Submission to the
Victorian Planning Authority

Small Lot Housing Code – Standards Review (Stage 2)

August 2022

Figure 9 – Rear entry door to lane

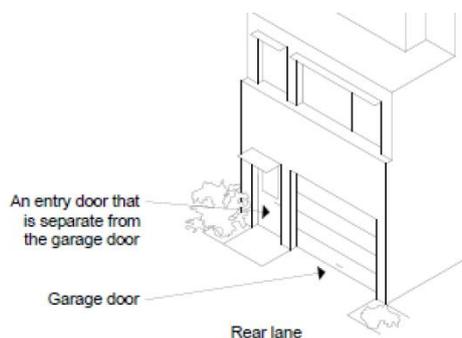
- This requirement is not supported as it mandates lot widths to be wider for a non-essential reason when the intention of Type C is to make lots more compact. Pedestrians can enter rear loaded lots via the garage door and do not need a dedicated pedestrian access. This also introduces a potential security breach point to the property, via unnecessary construction. We also note this not a requirement for Types A & B, therefore introduces an inconsistent outcome to the established code.

Image 1. Excerpt from CASBE/VPA *Sustainable Subdivisions Framework – Subdivision Example (with 13 lots)*

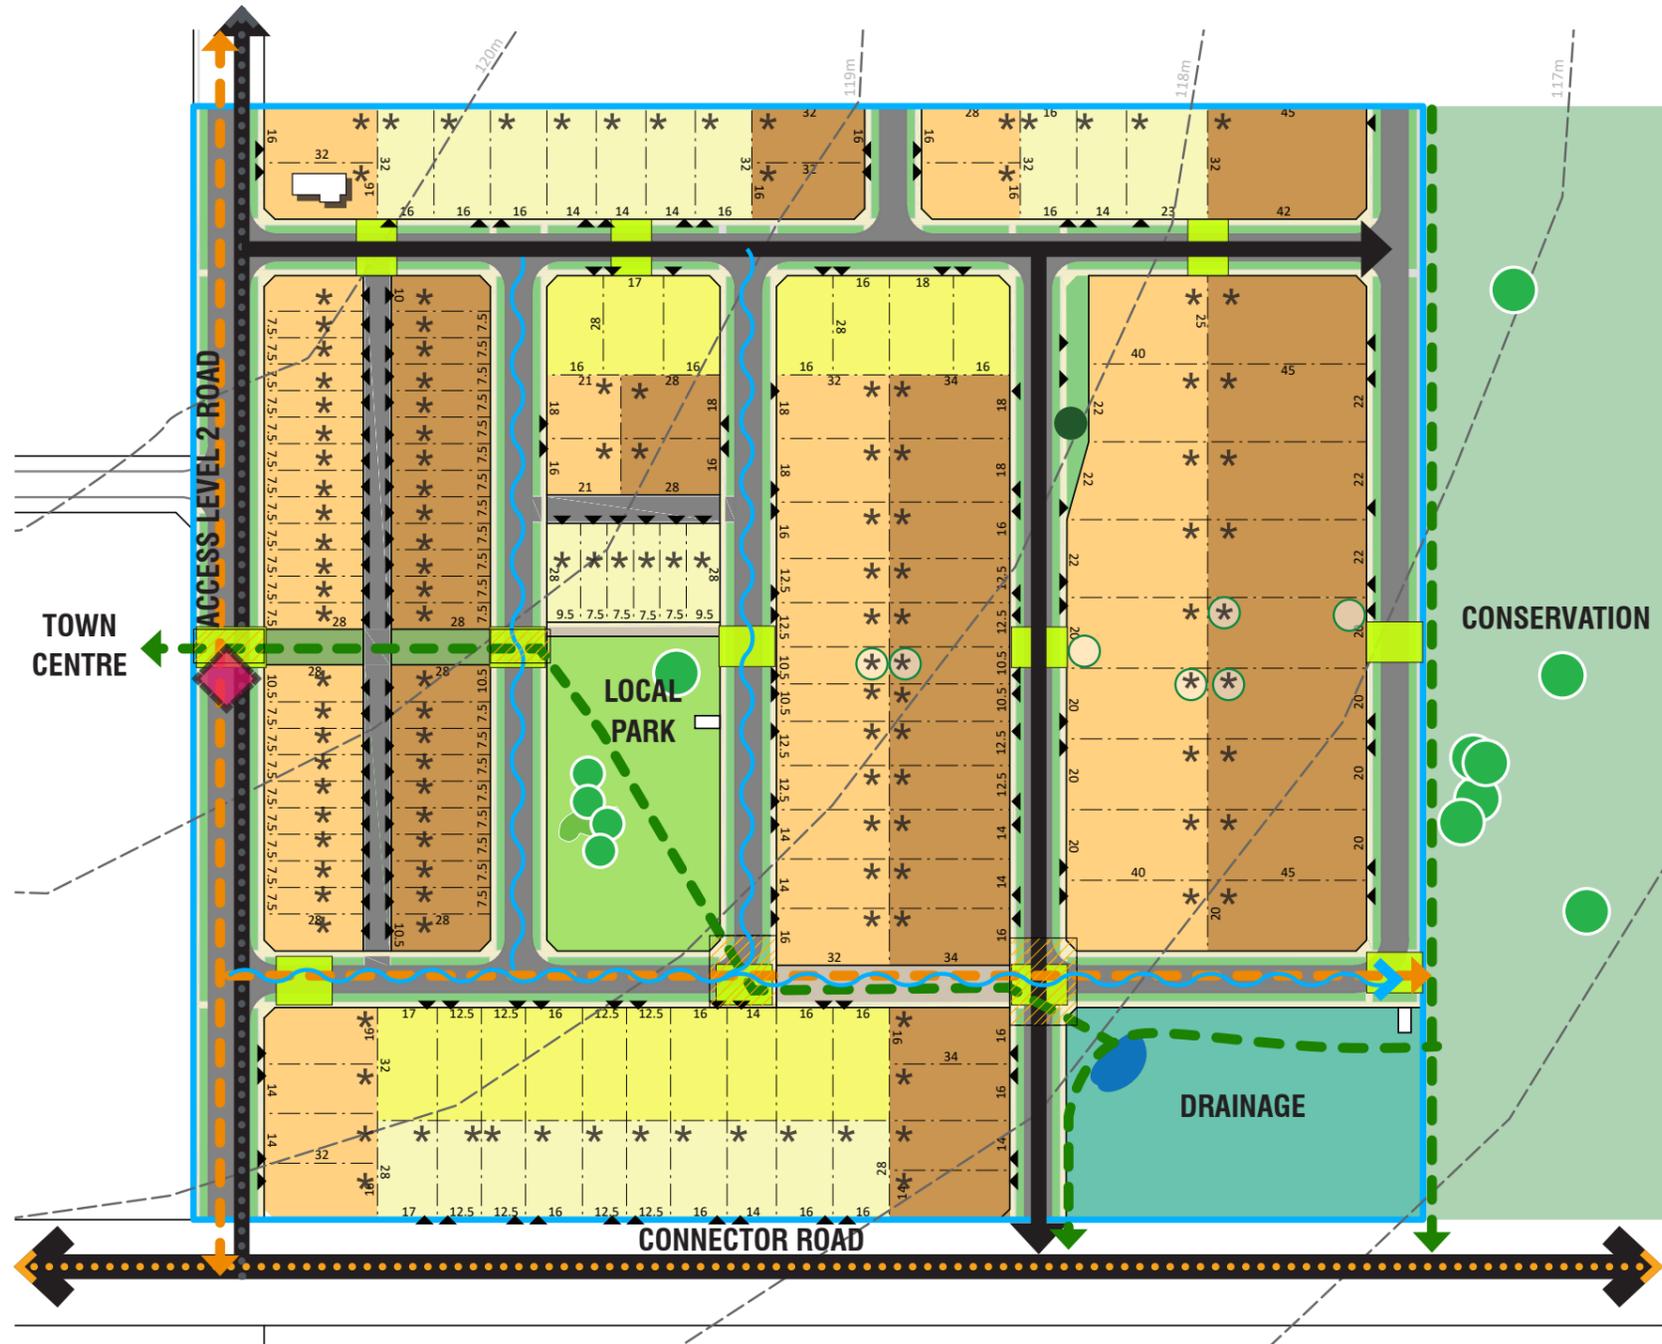
- The limitation of 10 continuous allotments and 60 metres is considered to be too restrictive. Removing this requirement will allow for a discretionary outcome to the satisfaction of the responsible authority. We note the Council Alliance for Sustainable Built Environment (CASBE) endorsed *Sustainable Subdivisions Framework – Subdivision Example plan* prepared for the VPA, includes a continuous row of 13 small lots (refer to image 1 below). This clearly demonstrates alternative outcomes can be supported and '10 allotments / 60 metres' should not be specified in the guidance material, otherwise applicants run the risk responsible authorities will adopt as a mandate. It also encourages broader outcomes for on street car parking and crossover design/locations.
